ACCESSION NBR: 8304110872 DDC DATE: 83/04/07 NOTARIZED: NO DOCKET #
 FACIL: 50-261 H. B. Robinson Plant, Unit 2, Carolina Power and Light 05000261
 AUTH. NAME AUTHOR AFFILIATION
 ZIMMERMAN, S. R. Carolina Power & Light Co.
 RECIP. NAME RECIPIENT AFFILIATION
 VARGA, S. A. Operating Reactors Branch 1

SUBJECT: Responds to NRC 830214 request for addl info re containment pressure, water & hydrogen monitors per NUREG-0737 Items II F.1.4., II F.1.5 & II F.1.6. Overall uncertainty determinations to be calculated after receipt of data.

H. B. ROBINSON STEAM ELECTRIC PLANT, UNIT NO. 2
DOCKET NO. 50-261
LICENSE NO. DPR-23
NUREG-0737, ITEMS II.F.1.4, II.F.1.5 AND II.F.1.6
CONTAINMENT PRESSURE, WATER LEVEL, AND HYDROGEN MONITORS

REQUEST FOR ADDITIONAL INFORMATION ON NUREG-0737 ITEMS

FIGURE 1. BLOCK DIAGRAM OF THE HBR2 CONTAINMENT PRESSURE MONITOR SYSTEM
(DUAL CHANNEL, ONLY ONE CHANNEL ILLUSTRATED)

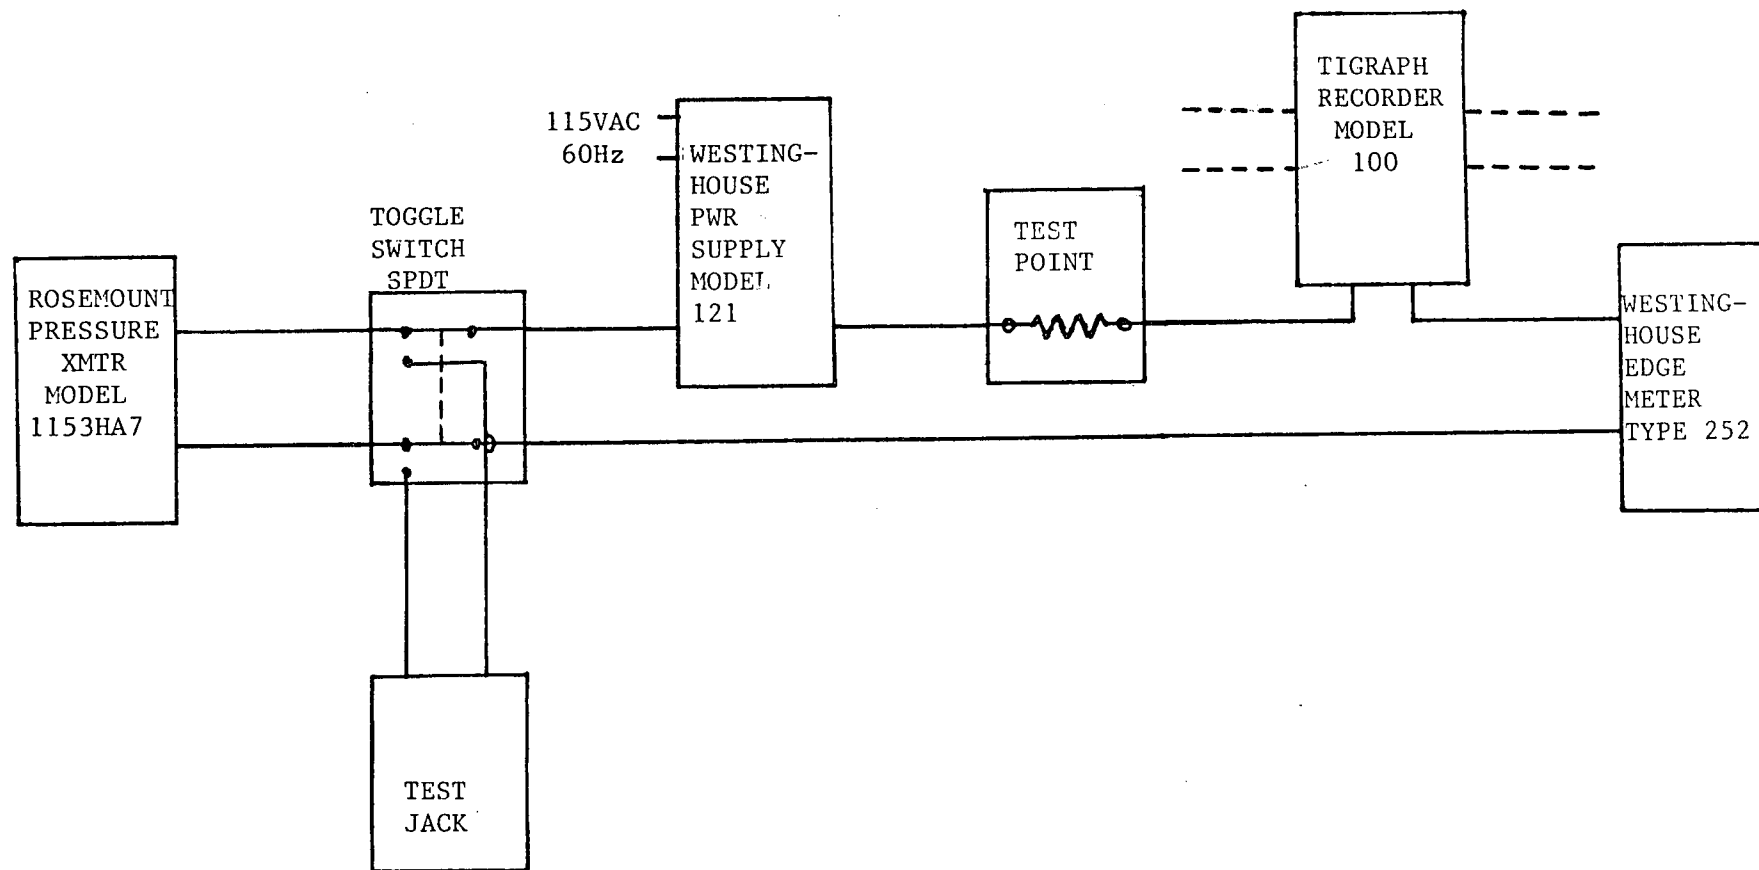
- (2a) Provide a block diagram of the configuration of modules that make up your PMS. Provide an explanation of any details in the block diagram that might be necessary for an understanding of your PMS accuracy and time response.

A block diagram of the configuration of modules which make up the HBR2 containment pressure monitor is included as Figure 1.

FIGURE 2. BLOCK DIAGRAM OF THE HBR2 WATER LEVEL MONITOR SYSTEM
(DUAL CHANNEL, ONLY ONE CHANNEL ILLUSTRATED)

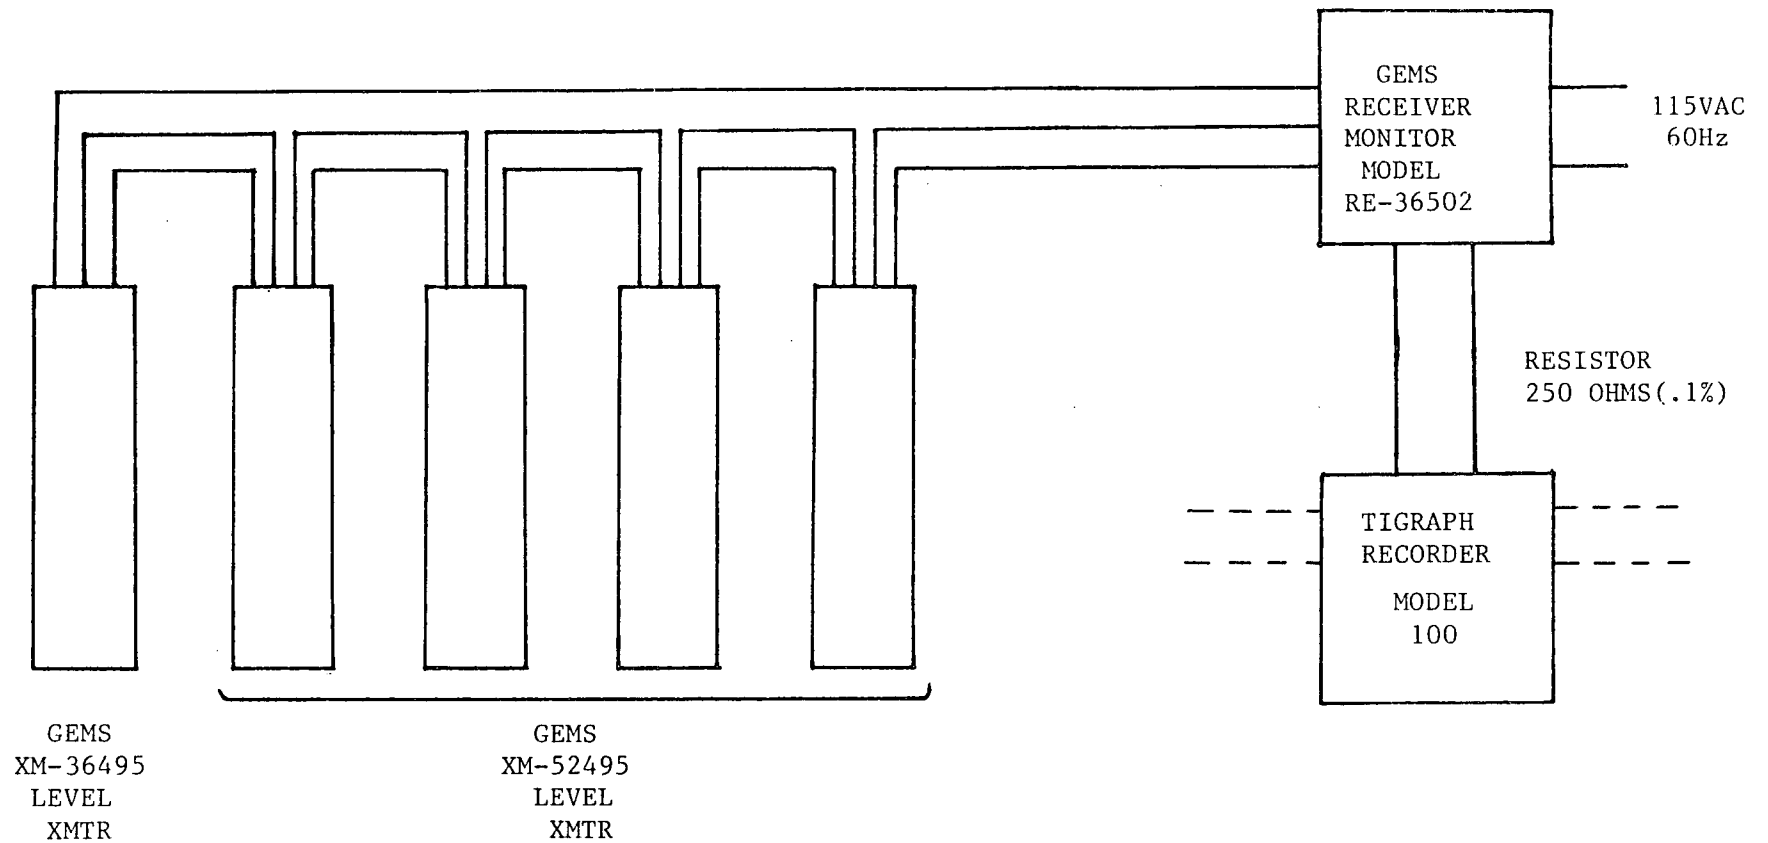
- (3a) Provide a block diagram of the configuration of modules that make up your WLMS. Provide an explanation of any details in the block diagram that might be necessary for an understanding of your WLMS accuracy.

A block diagram of the configuration of modules which make up the HBR2, containment water level monitor is included as Figure 2.

FIGURE 3. BLOCK DIAGRAM OF THE HBR2 HYDROGEN MONITOR SYSTEM
(DUAL CHANNEL, ONLY ONE CHANNEL ILLUSTRATED)

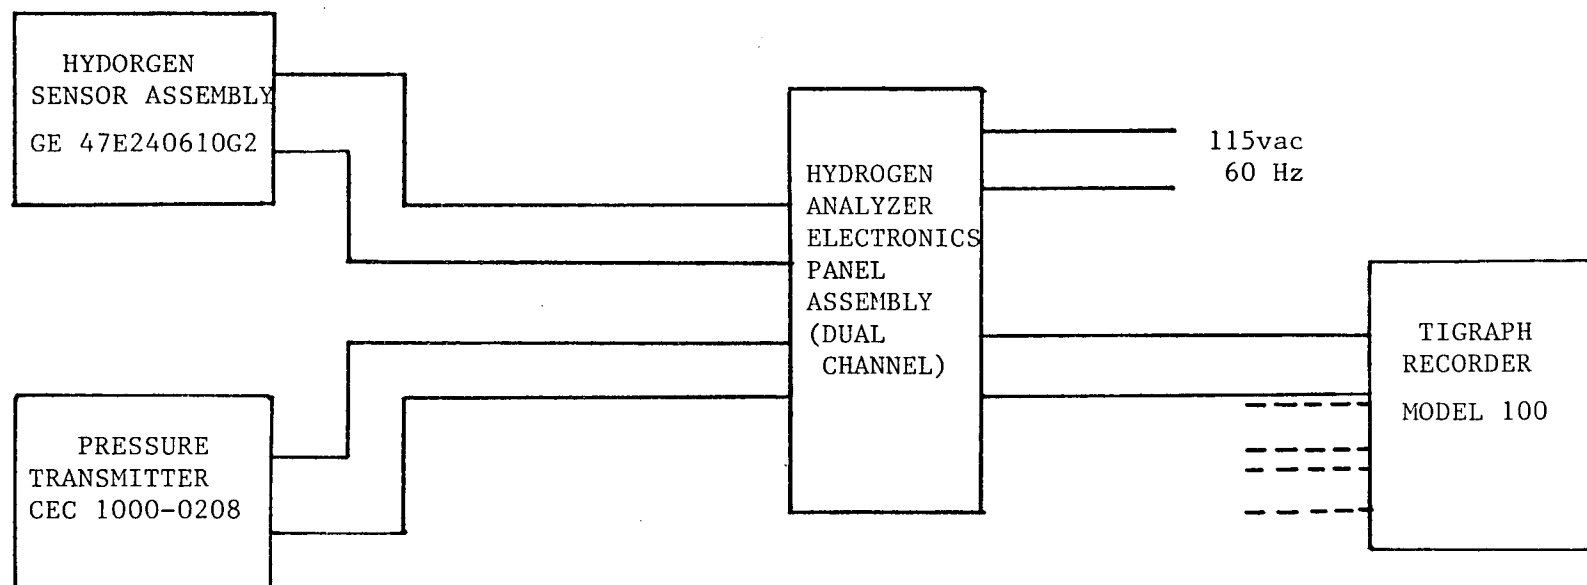
- (4a) Provide a block diagram of the configuration of modules that make up your HMS. Provide an explanation of any details in the block diagram that might be necessary for an understanding of your HMS accuracy. If you have different types of HMSs give this information for each type.

A block diagram of the configuration of modules which make up the HBR2 containment hydrogen monitor is included as Figure 3.
